**OGP's contribution to the review**  
**of Best Available Techniques Reference Document (BREF)**  
**for Large Combustion Plants (LCP)**

**Executive Summary**

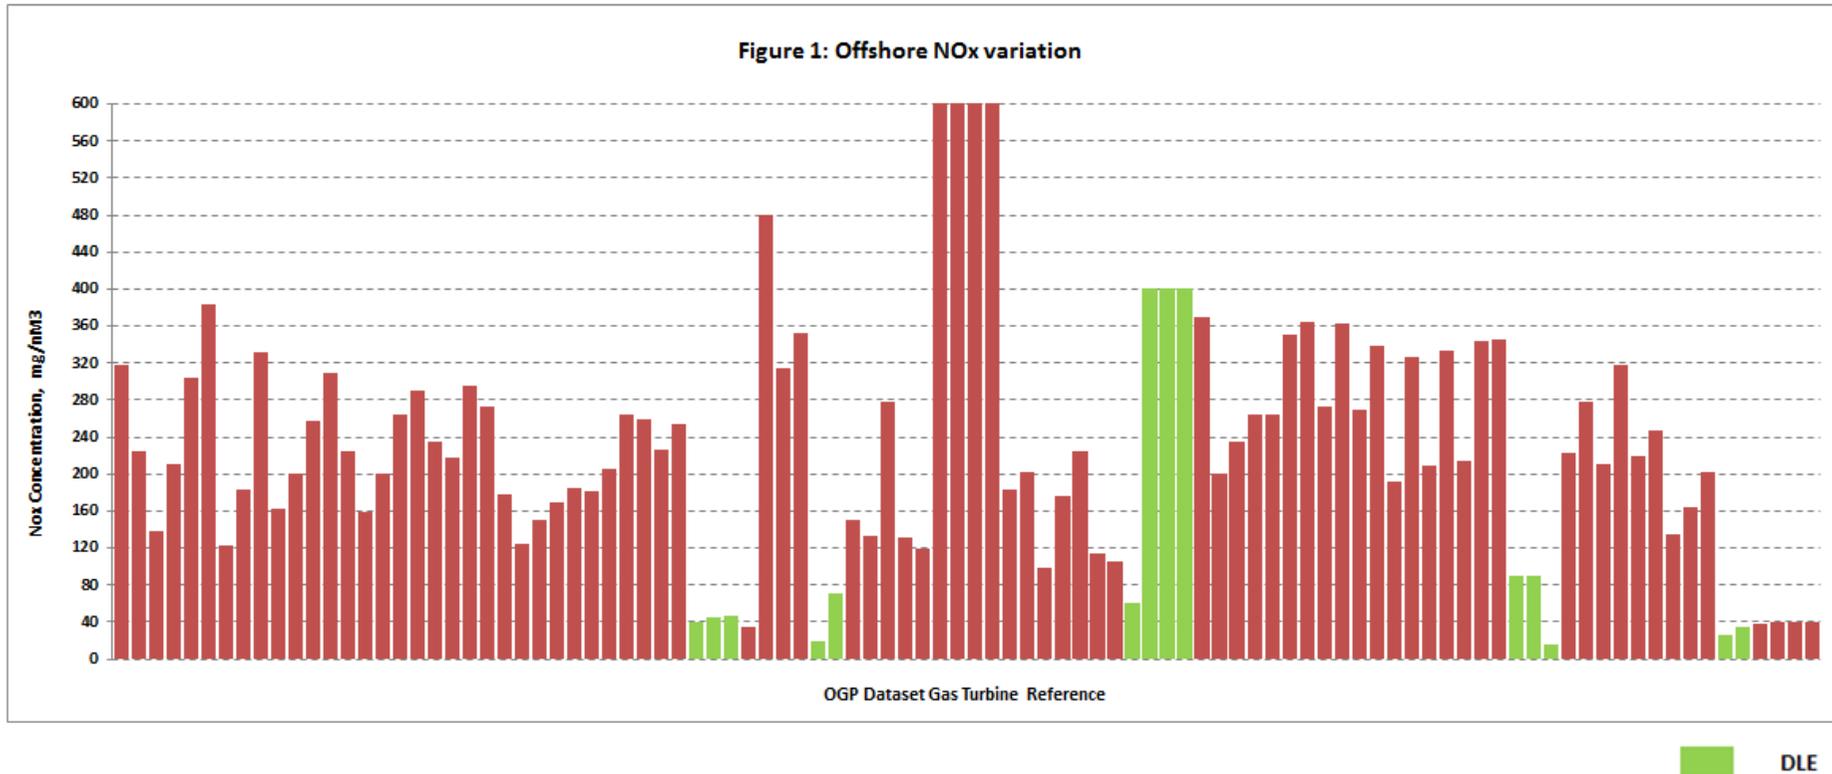
Existing plants: the current range for ELVs do not reflect current operating experience. It needs to be made clear that the limits as shown can only apply above 70% loading. Since DLN on dual fuel is not fully proven for offshore there needs to be a condition that the range as shown (all table 10.37) only apply on single fuel GTs and > 70% loading.<sup>2</sup>

<sup>2</sup> Please see figures and observations in Appendix.

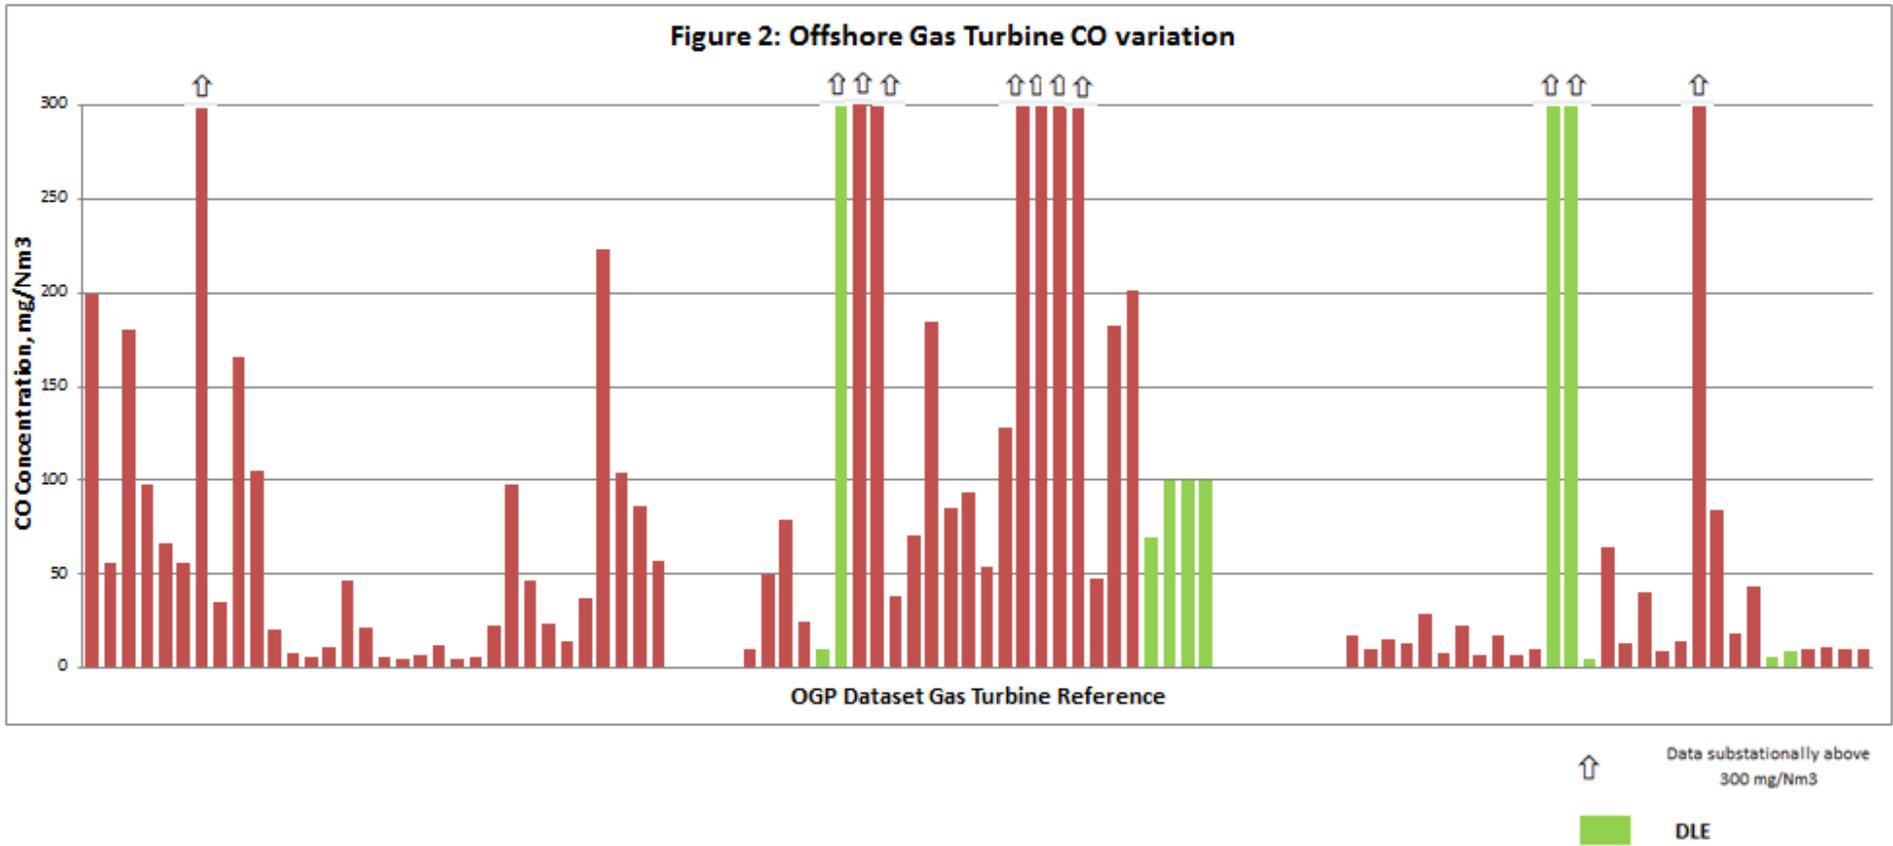
From the OGP dataset provided, consisting of 98 Gas Turbines, the following conclusions can be drawn:

- Only 14 (15%) of these Gas Turbines are DLE
- Vast majority, 79 (80%), are dual fuel (gas and diesel)
- Majority, 71 (72%), are on Power duty (as opposed to Compression)
- Majority of Gas Turbines at low / Medium loading, especially for power duties
- Loading a significant issue with regards NOx concentration i.e. much higher at lower loads
